Amendments to the Drawings:

REMARKS

Fig. 1

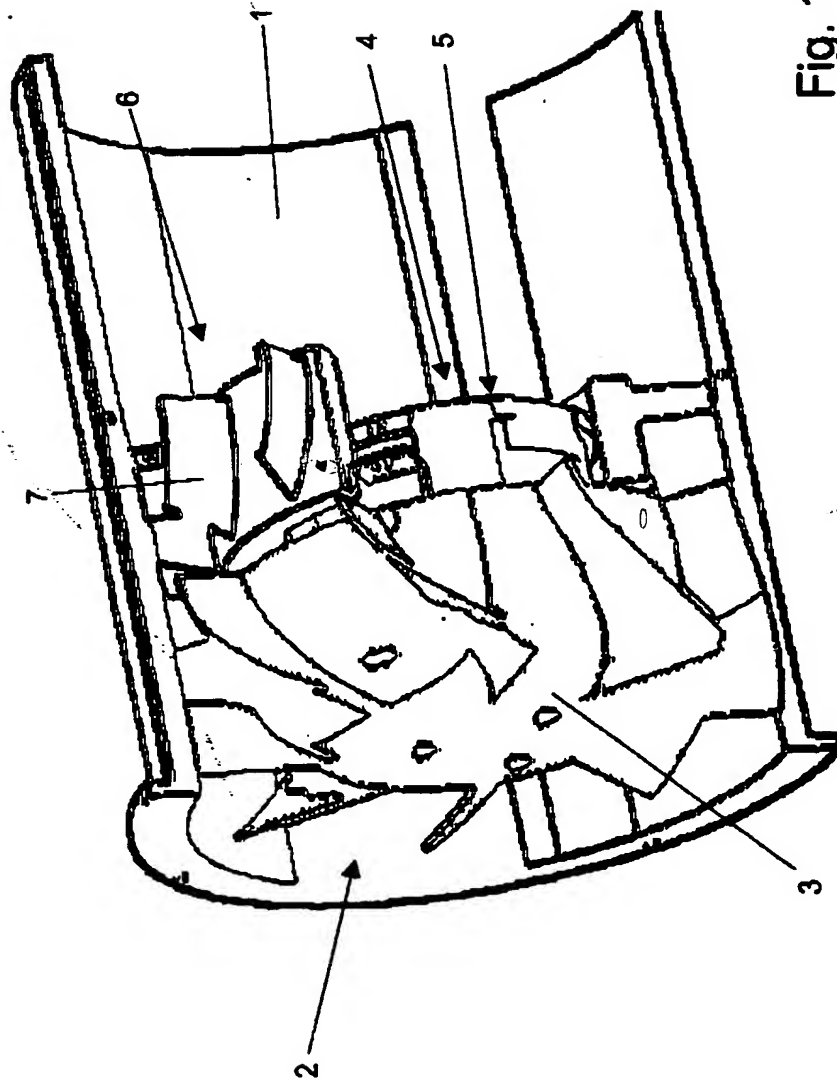
ROTATED FIGURE
CLOCKWISE 90°

Fig. 2

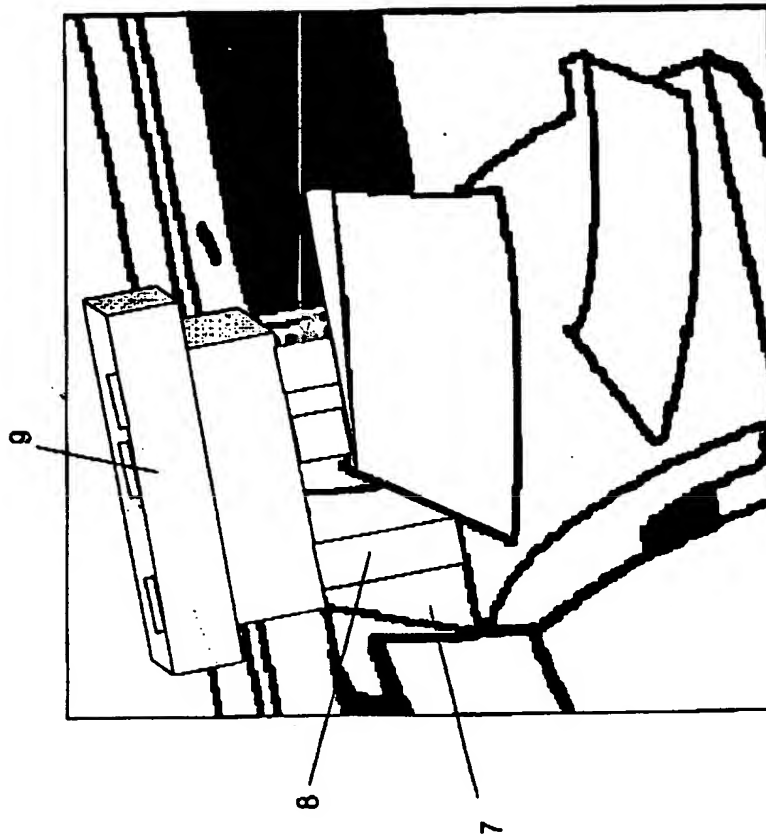
ROTATED FIGURE
CLOCKWISE 90°
AND REPLACED SOLID
BLACK AREAS WITH
DASHED LINES

Fig. 3

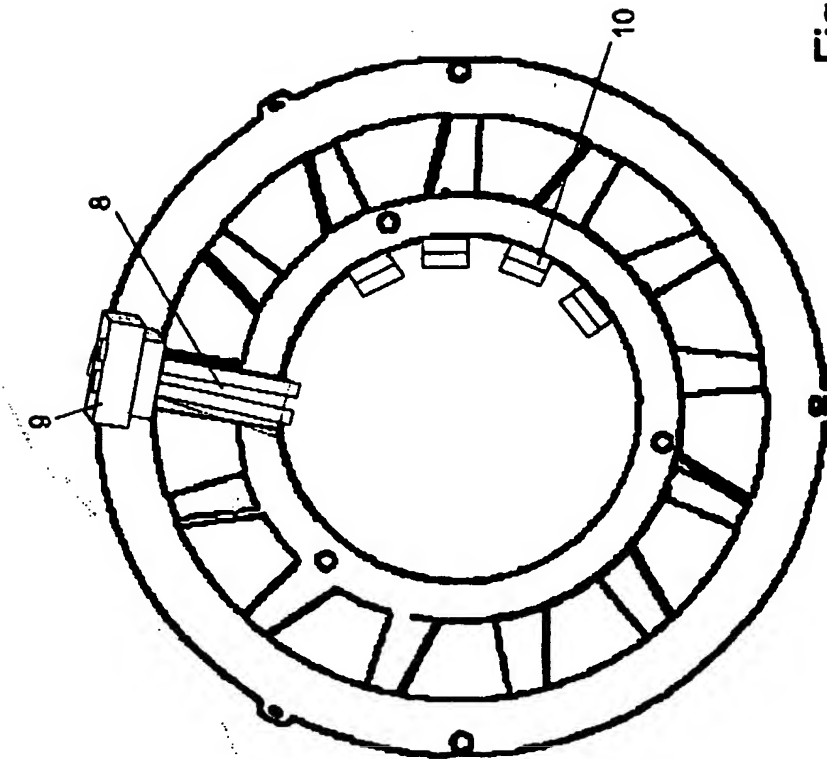
ROTATED FIGURE
CLOCKWISE 90°

Fig. 4

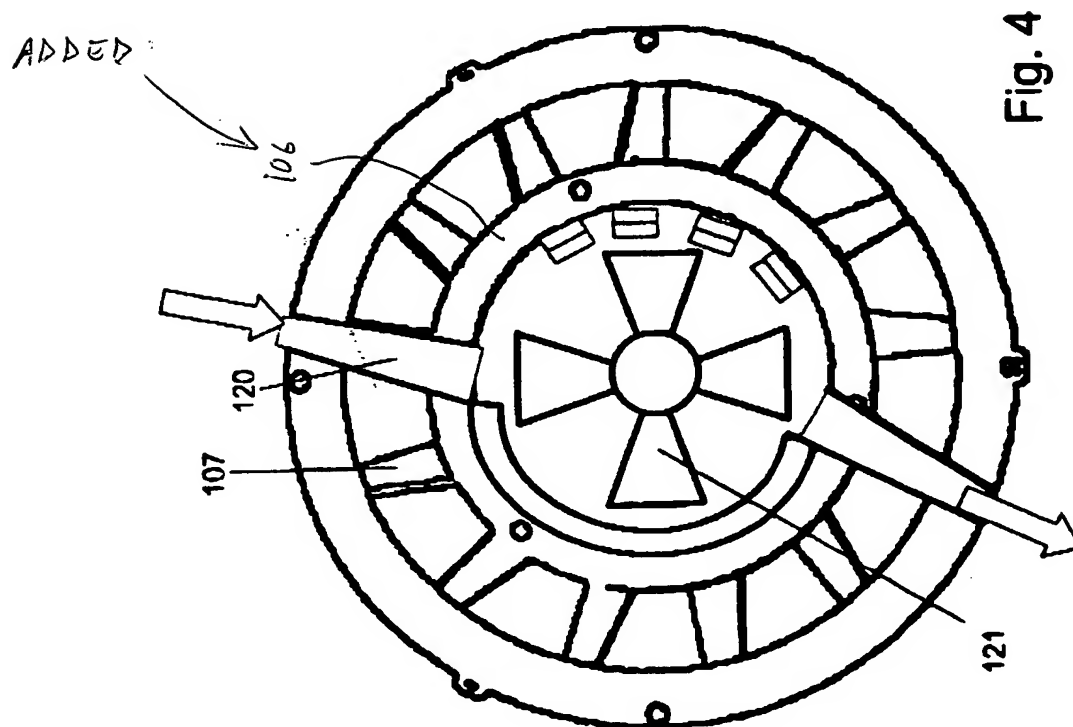
The specific changes which have been made to the Figures are to rotate Figures 1-3 clockwise 90°, to remove the solid black region from Figure 2, to add element 106 to Figure 4, and to present new formal drawings with smooth lines.
